ATTACHMENT B

AFFECTED TECHNICAL SPECIFICATION PAGES

LICENSE DPR-19/25

ComEd proposes to amend Appendix A, Technical Specifications, Section 3/4.6.K of Facility Operating Licenses DPR-19, DPR-25, DPR-29 and DPR-30. The amendment request changes the pressure temperature (P-T) curves, Figure 3.6.K-1 and associated Bases.

FIGURE 3.6.K-1

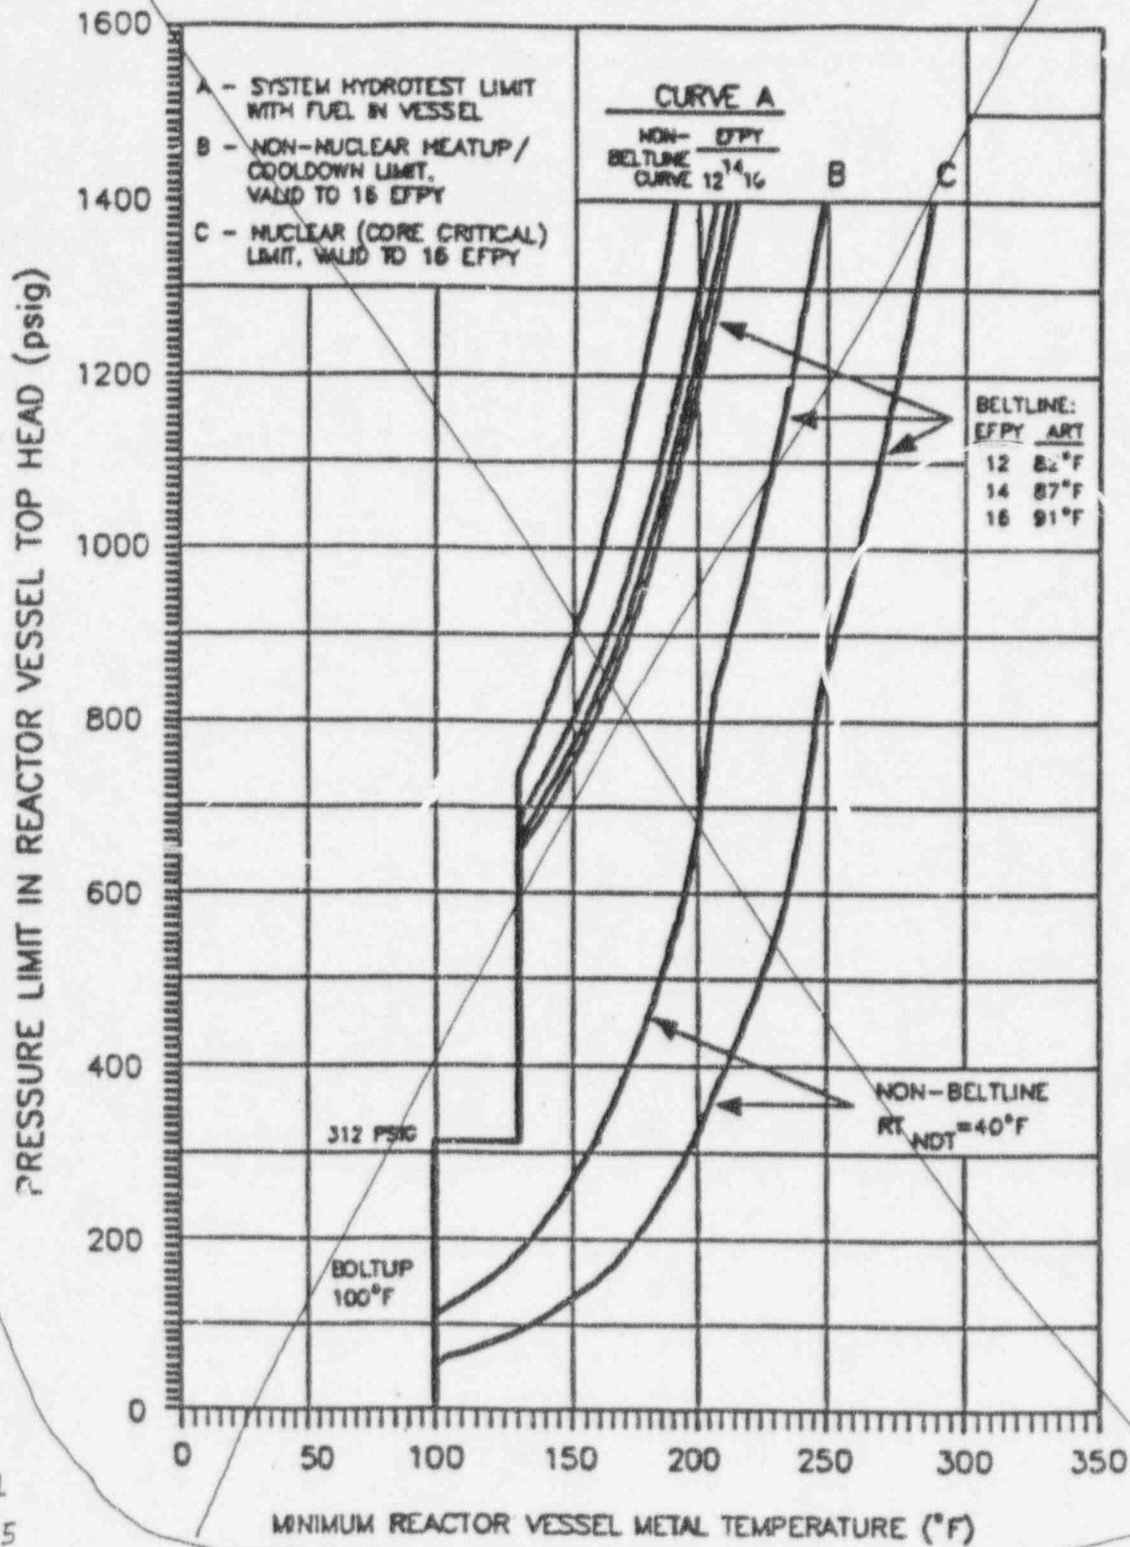
The reactor coolant system temperature and pressure shall be limited in accordance with the limit lines shown on Figure 3.6.K-1 (1) curve A for hydrostatic or leak testing; (2) curve B for heatup by non-nuclear means, cooldown following a nuclear shutdown and low power PHYSICS TESTS; and (3) curve C for operations with a critical core other than low power PHYSICS TESTS, with:

Replace with
Figures 3.6.K-1
through 3.6.K-5

- a. The reactor vessel metal temperature and pressure shall be maintained within the Acceptable Regions as shown on Figures 3.6.K-1 through 3.6.K-3 with the rate of change of the primary system coolant temperature $\leq 20^{\circ}\text{F}$ per hour, or
- b. The rate of change of the primary system coolant temperature shall be $\leq 100^{\circ}\text{F}$ per hour when reactor vessel metal temperature and pressure is maintained within the Acceptable Regions as shown on Figure 3.6.K-4.

- a. The reactor vessel metal temperature and pressure shall be maintained within the Acceptable Regions as shown on Figure 3.6.K-4, and
- b. The rate of change of the primary system coolant temperature shall be $\leq 100^{\circ}\text{F}$ per hour.

- a. The reactor vessel metal temperature and pressure shall be maintained within the Acceptable Region as shown on Figure 3.6.K-5, and
- b. The rate of change of the primary system coolant temperature shall be $\leq 100^{\circ}\text{F}$ per hour.

FIGURE 3.6.K-1

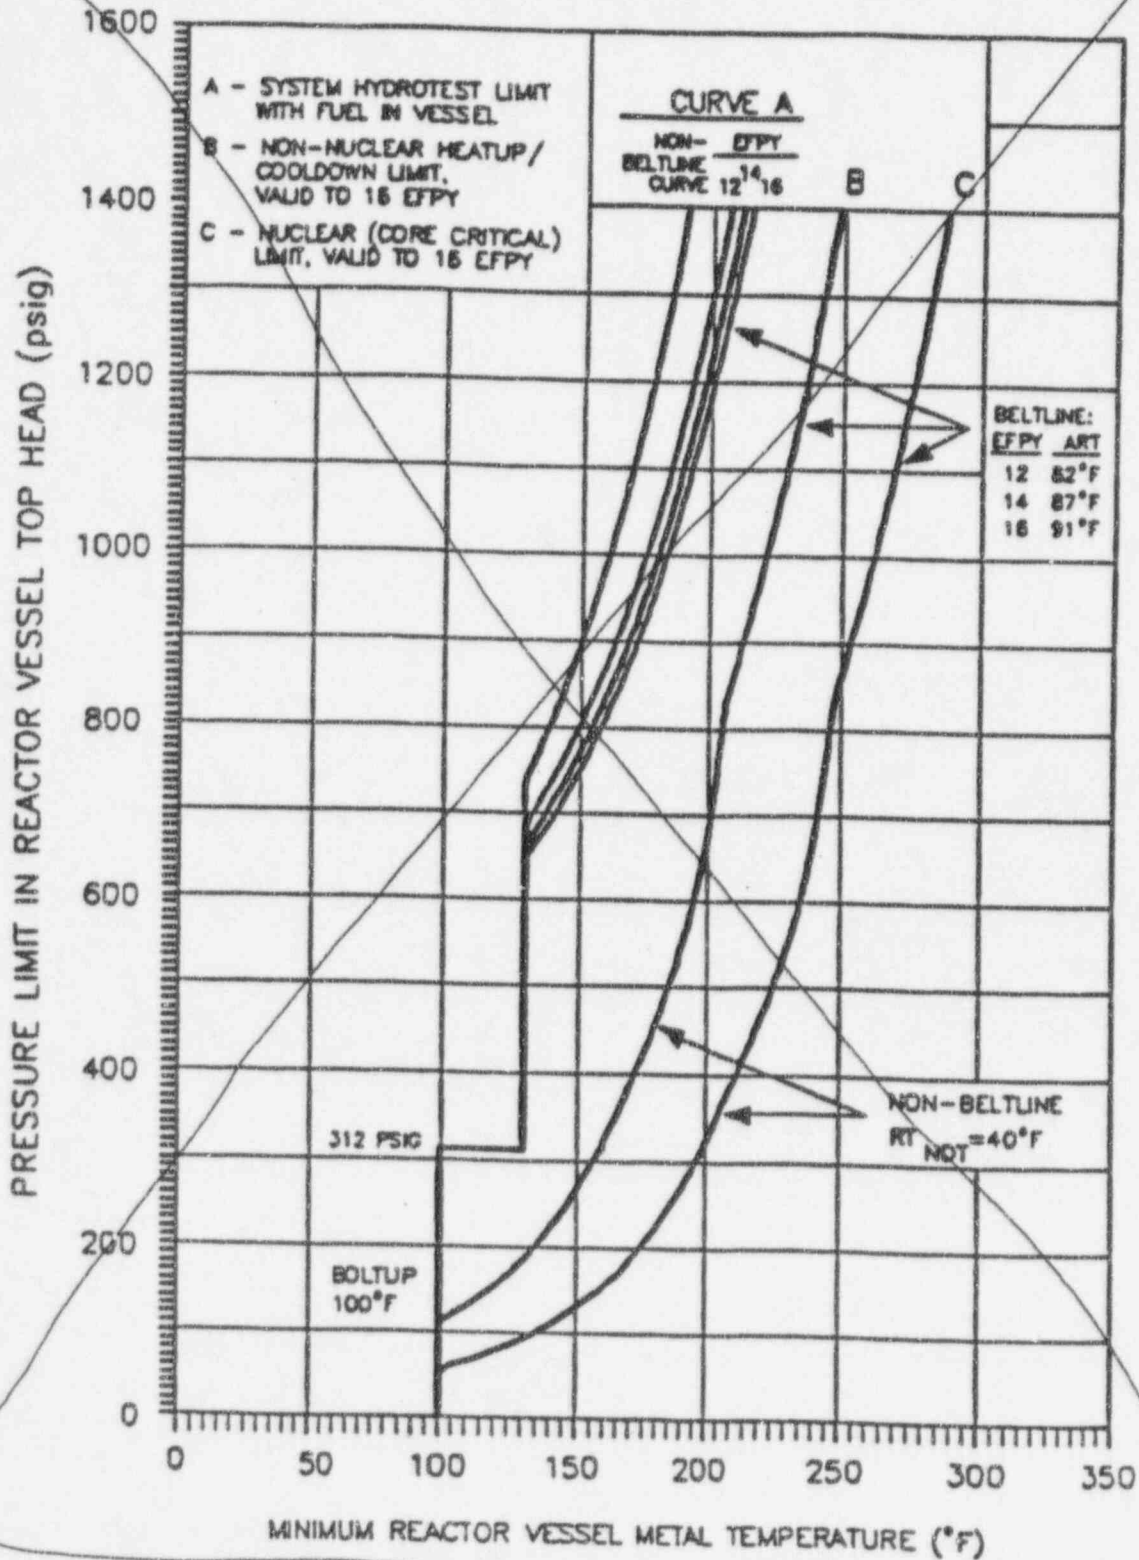
The reactor coolant system temperature and pressure shall be limited in accordance with the limit lines shown on Figure 3.6.K-1 (1) curve A for hydrostatic or leak testing; (2) curve B for heatup by non-nuclear means, cooldown following a nuclear shutdown and low power PHYSICS TESTS; and (3) curve C for operations with a critical core other than low power PHYSICS TESTS, with:

INSERT 'A' →

1. Pressure Testing:
 - a. The reactor vessel metal temperature and pressure shall be maintained within the Acceptable Regions as shown on Figures 3.6.K-1 through 3.6.K-3 with the rate of change of the primary system coolant temperature $\leq 20^{\circ}\text{F}$ per hour, or
 - b. The rate of change of the primary system coolant temperature shall be $\leq 100^{\circ}\text{F}$ per hour when reactor vessel metal temperature and pressure is maintained within the Acceptable Regions as shown on Figure 3.6.K-4.
2. Non-Nuclear Heatup and Cooldown and low power PHYSICS TESTS:
 - a. The reactor vessel metal temperature and pressure shall be maintained within the Acceptable Regions as shown on Figure 3.6.K-4, and
 - b. The rate of change of the primary system coolant temperature shall be $\leq 100^{\circ}\text{F}$ per hour.

- a. The reactor vessel metal temperature and pressure shall be maintained within the Acceptable Region as shown on Figure 3.6.K-5, and
- b. The rate of change of the primary system coolant temperature shall be $\leq 100^{\circ}\text{F}$ per hour.

FIGURE 3.6.K-1

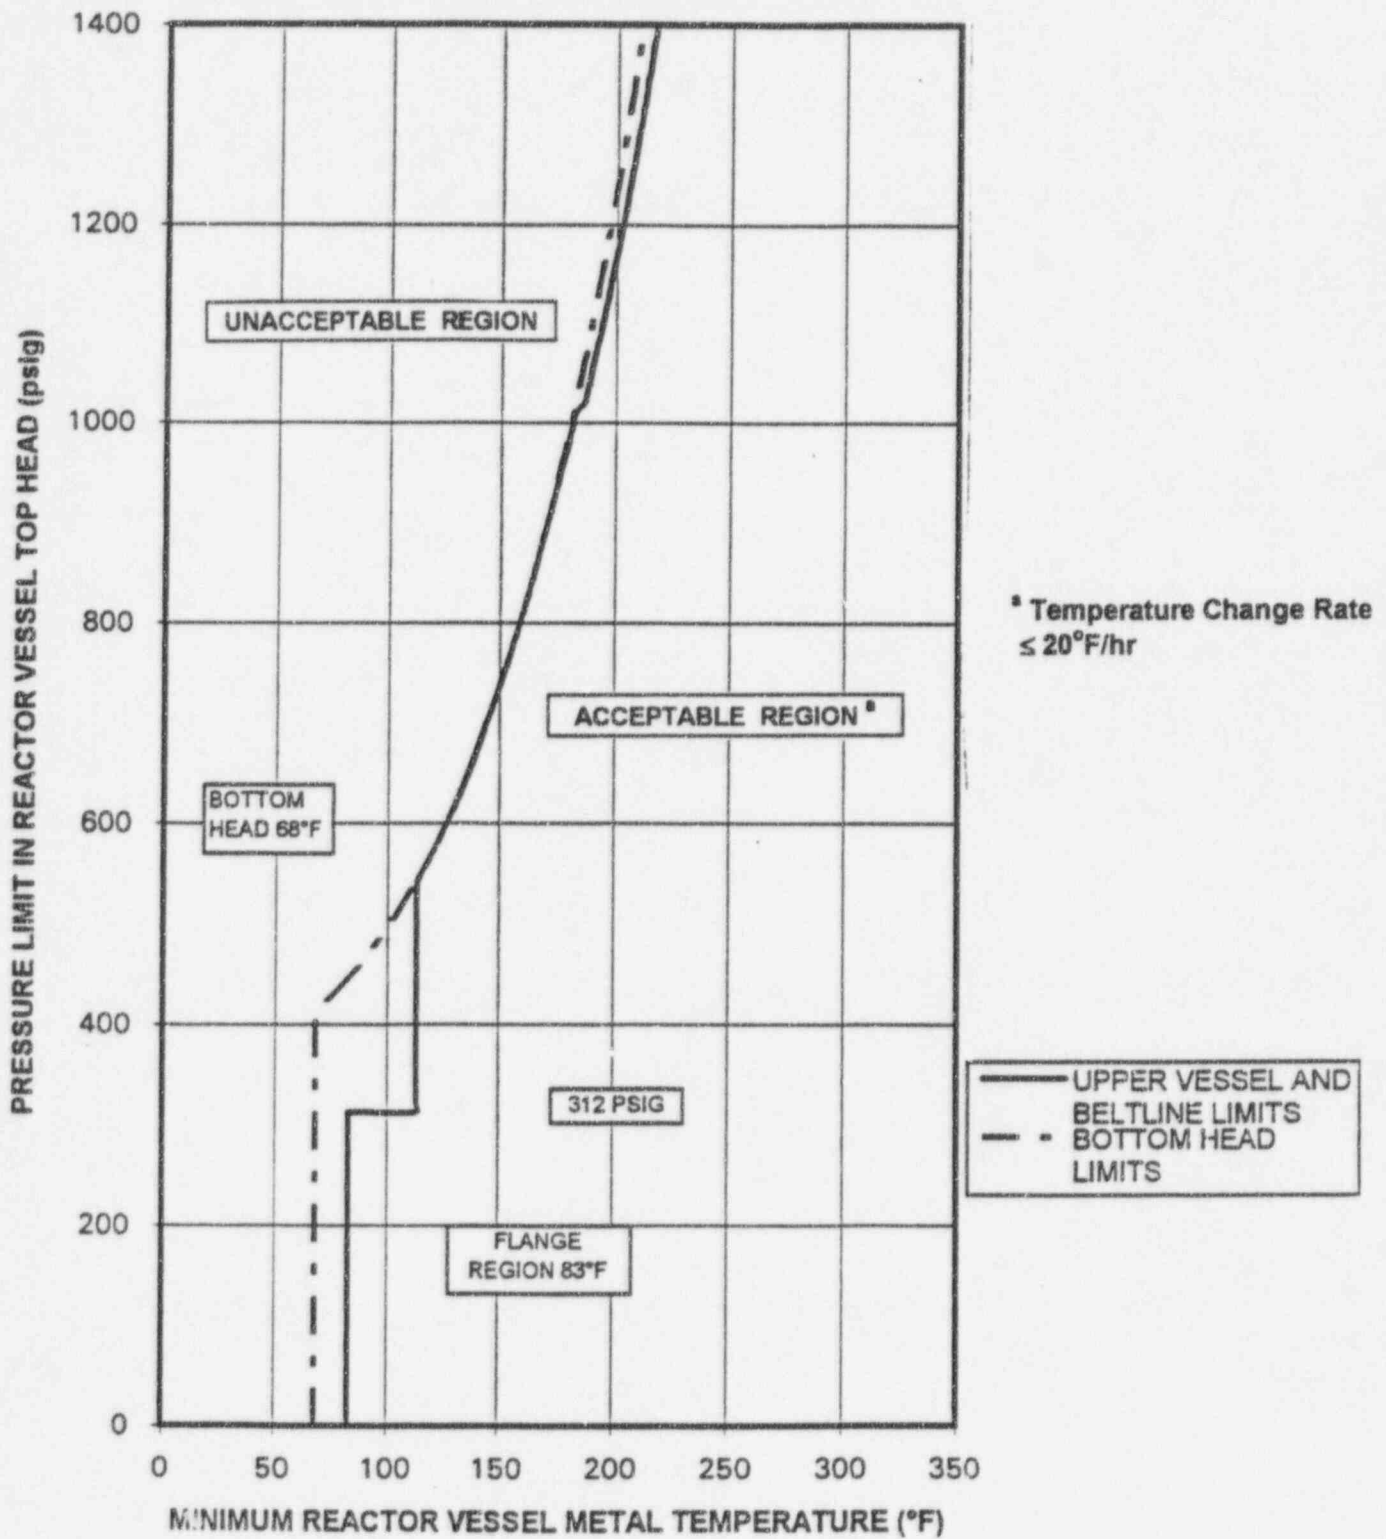
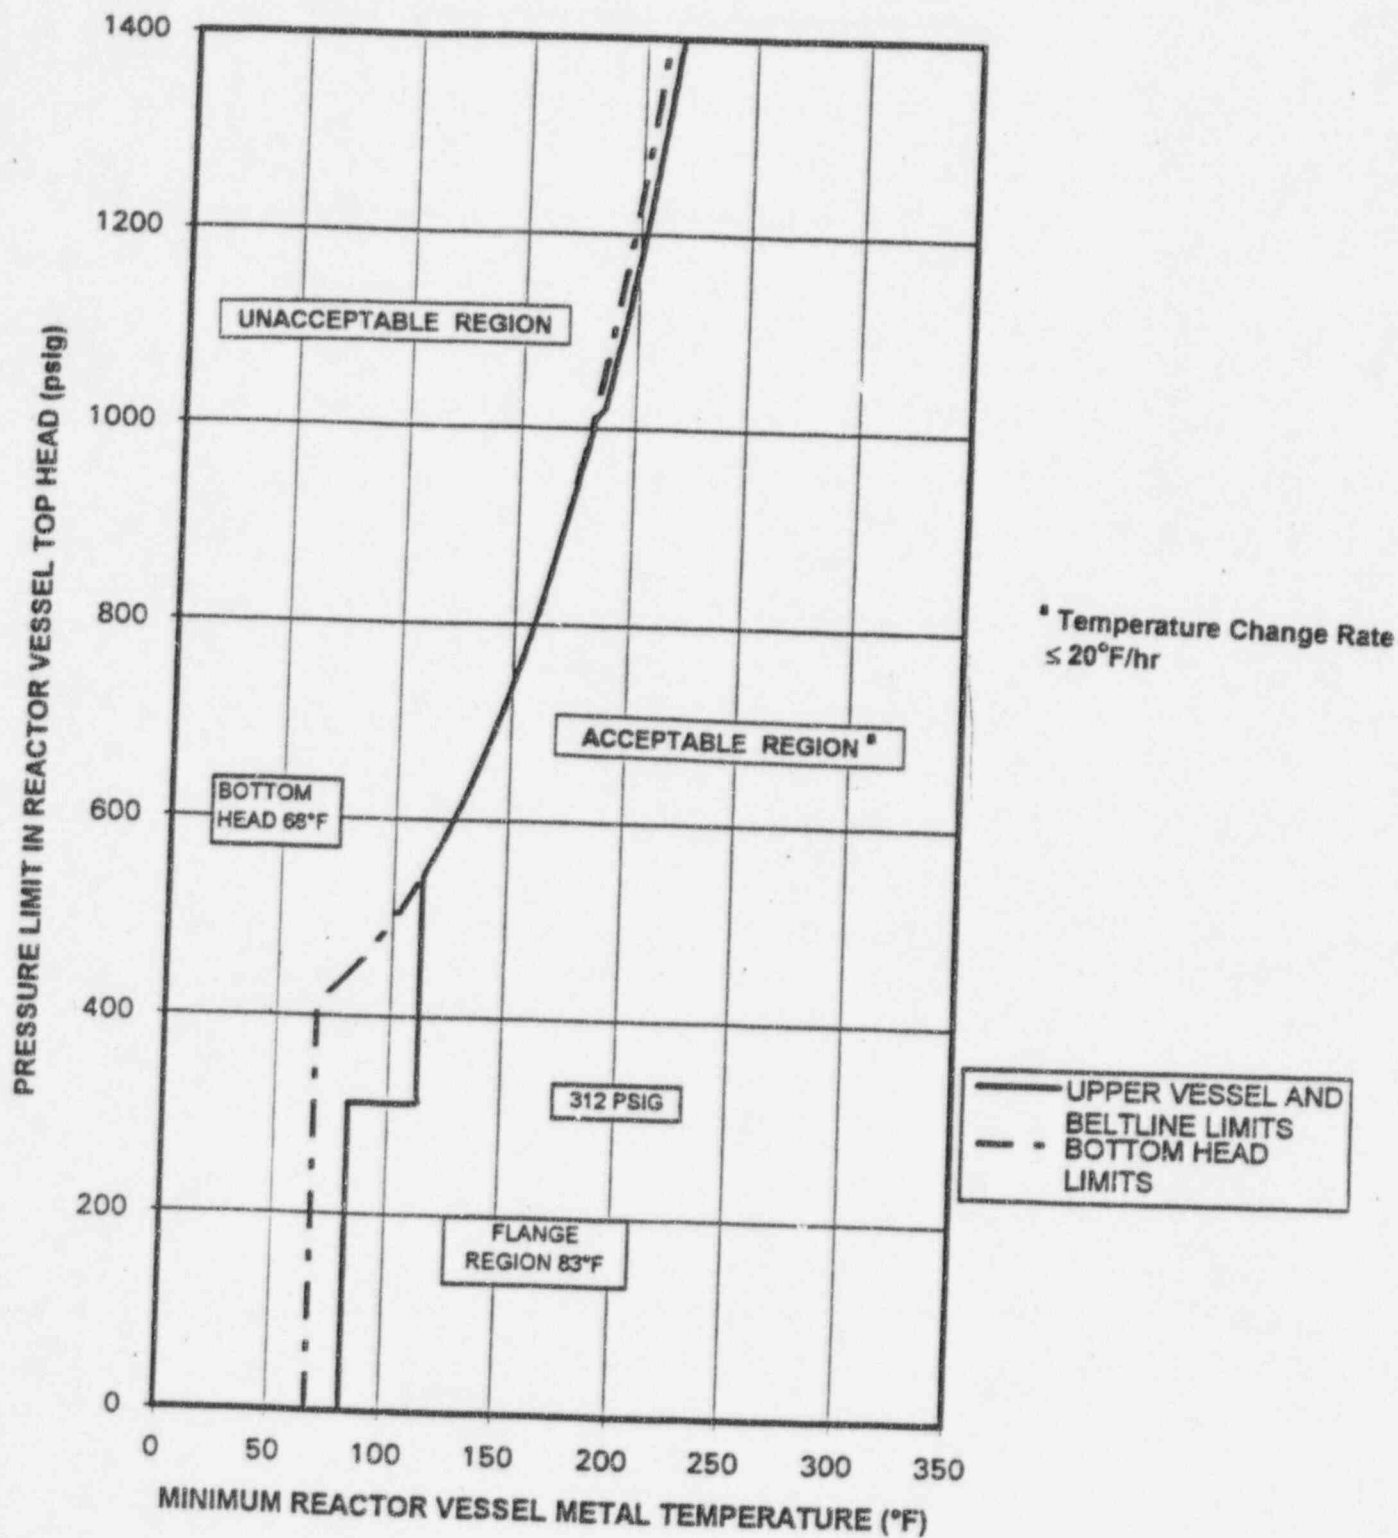
The proposed amendment reflect an update of the P-T curves to extend the operating limit to 22 EFPY. The revised curves are based on the latest NRC guidance along with actual data for the units. The new limits retain the margin of safety to the level expected for a new vessel, adjusted for irradiation effects as required by 10CFR, Appendix G, thereby maintaining a conservative margin of safety.

As indicated in Figure 3.6.K-1 through 3.6.K-3 for pressure testing, the minimum metal temperature of the reactor vessel shell is 83°F for reactor pressures less than 312 psig. This 83°F minimum boltup temperature is based on a RT_{NDT} of 23°F for the electrosag weld immediately below the vessel flange and a 60°F conservatism required by the original ASME Code of construction. The bottom head region limit is established as 68°F, based on moderator temperature assumptions for shutdown margin analyses. At reactor pressures greater than 312 psig, the minimum vessel metal temperature is established as 113°F. The 113°F minimum temperature is based on a closure flange region RT_{NDT} of 23°F and a 90°F conservatism required by 10CFR Part 50 Appendix G. Beltline curves as a function of vessel exposure for 18, 20 and 22 effective full power years (EFPY) are presented to allow the use of the appropriate curve up to 22 EFPY of operation.

As indicated in Figure 3.6.K-1 through 3.6.K-3 for pressure testing, the minimum metal temperature of the reactor vessel shell is 83°F for reactor pressures less than 312 psig. This 83°F minimum boltup temperature is based on a RT_{NDT} of 23°F for the electroslag weld immediately below the vessel flange and a 60°F conservatism required by the original ASME Code of construction. The bottom head region limit is established as 68°F, based on moderator temperature assumptions for shutdown margin analyses. At reactor pressures greater than 312 psig, the minimum vessel metal temperature is established as 113°F. The 113°F minimum temperature is based on a closure flange region RT_{NDT} of 23°F and a 90°F conservatism required by 10CFR Part 50 Appendix G. Beltline curves as a function of vessel exposure for 18, 20 and 22 effective full power years (EFPY) are presented to allow the use of the appropriate curve up to 22 EFPY of operation.
